Stormwater Division

General File ID or BMP ID: JR031

County Plan No.: S-21-93
Project Name: Governors Land
Stormwater Management Facility: Wingfield Lake East Timber Crib Wall
Phase: I II III

Re: Governor's Land - Wingfield Lake
County Plan No. S -21-93
Timber Crib Wall
County BMP ID Code: JR 031

PLAN VIEW
PRESSURE TREATED WOOD DRY DETENTION STRUCTURE
N.T.S.

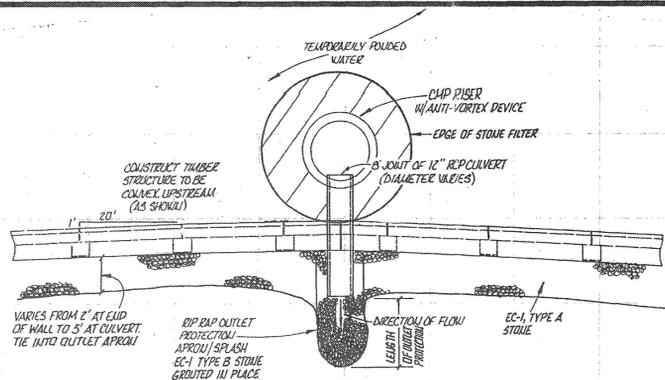
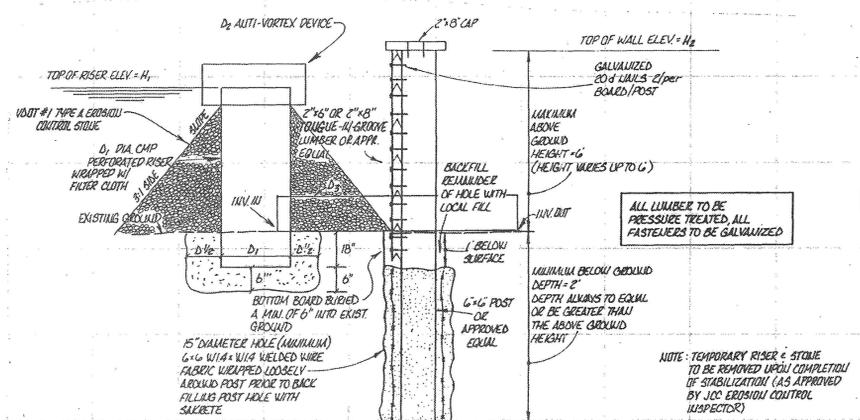
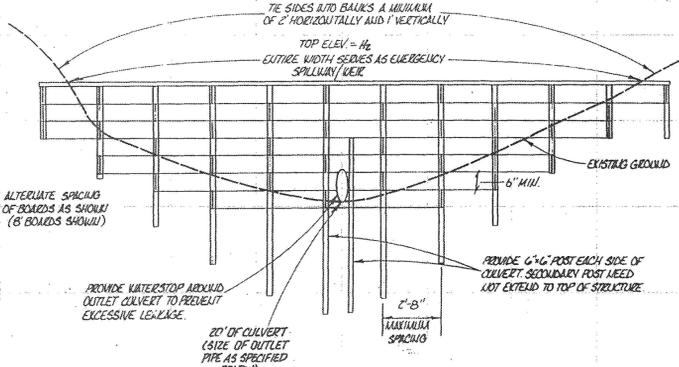
- ✓ Action*
1. Based on a review of the approved plan and active file for the project, there appears to be no construction certification requirement imposed on this BMP.

- ✓ OK
6-2-03*
3. Clean and remove accumulated vegetation, sediment and organic material from the rock filter which surrounds the riser structure. Inflow through the low flow orifice shall not be obstructed.

Construction – Related Items:
Organic material and debris was cleared for approximately 30 feet out from the timber wall on both the upstream and downstream sides. Rock filter was reestablished that surrounds the riser and stone on downstream side was replaced. Outflow protection was reestablished per approved plans.

HENRY S. BRANSCOME, LLC
GOVERNOR'S LAND TIMBER
WALL REPAIRS
4/19/11

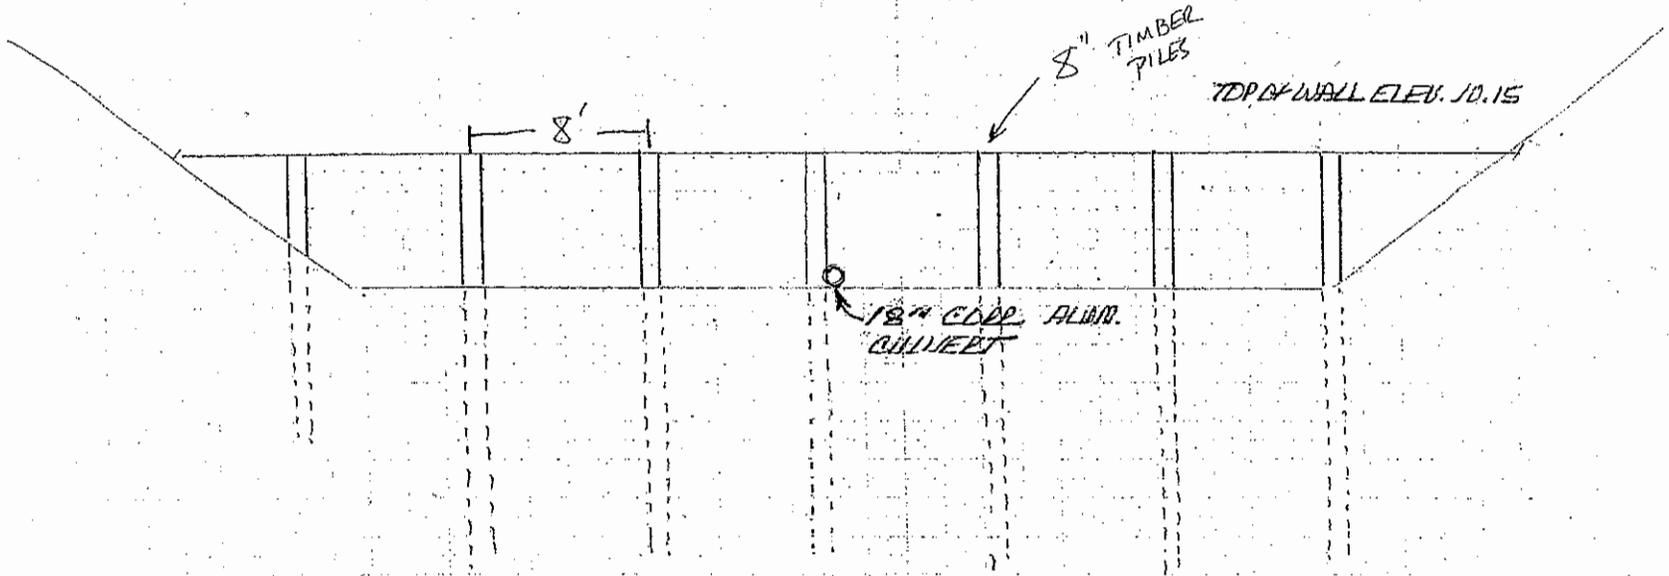
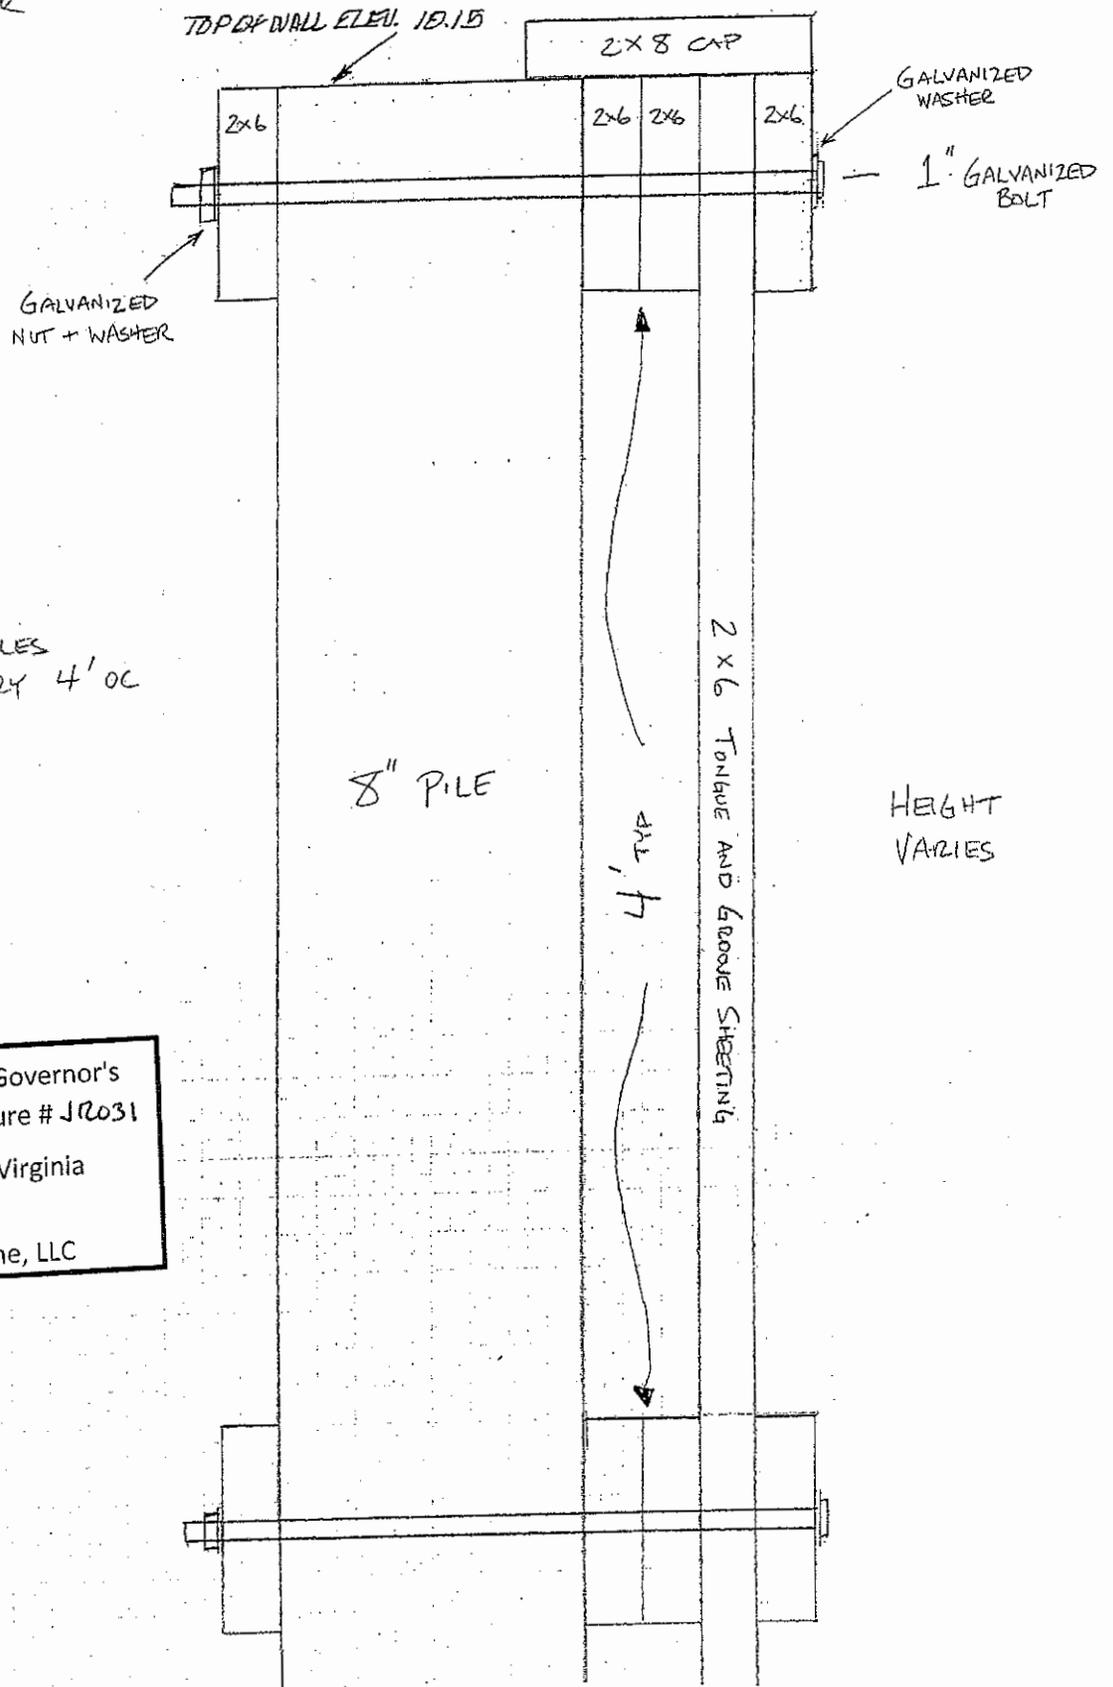
CONSTRUCTION NOTES:

Riprap Class I will be placed on the downstream side
And under laid with filter fabric.

Filter fabric will be installed on the upstream
Side of the 2 X 6 sheeting from the wall crest to 4'
Below existing grade.

Approved by: *PTM*
5/3/11
